Los Angeles Regional Water Quality Control Board

SUBJECT: REVIEW AND COMMENTS ON REVISED SOIL REUSE PLAN

FORMER CHEMOIL REFINERY, 2020 WALNUT AVENUE, SIGNAL HILL,

CALIFORNIA 90755 (SCP NO. 1391, SITE ID NO. 2040510)

Figure 1 – Conceptual Grading and Utility Plan

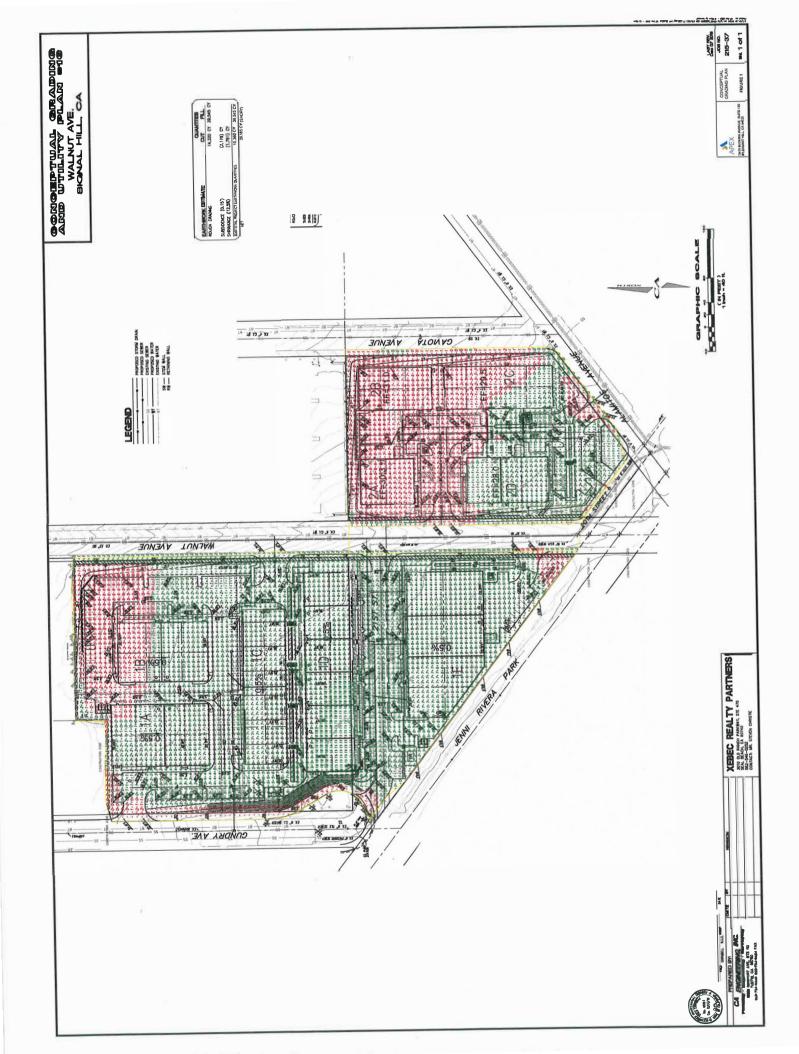
- > Figure 1 (attached) provides a conceptual grading plan that is designed to minimize excavation of soil where highest soil contamination is expected.
 - o Areas in red are where soil will be excavated, and fill areas are shown in green.
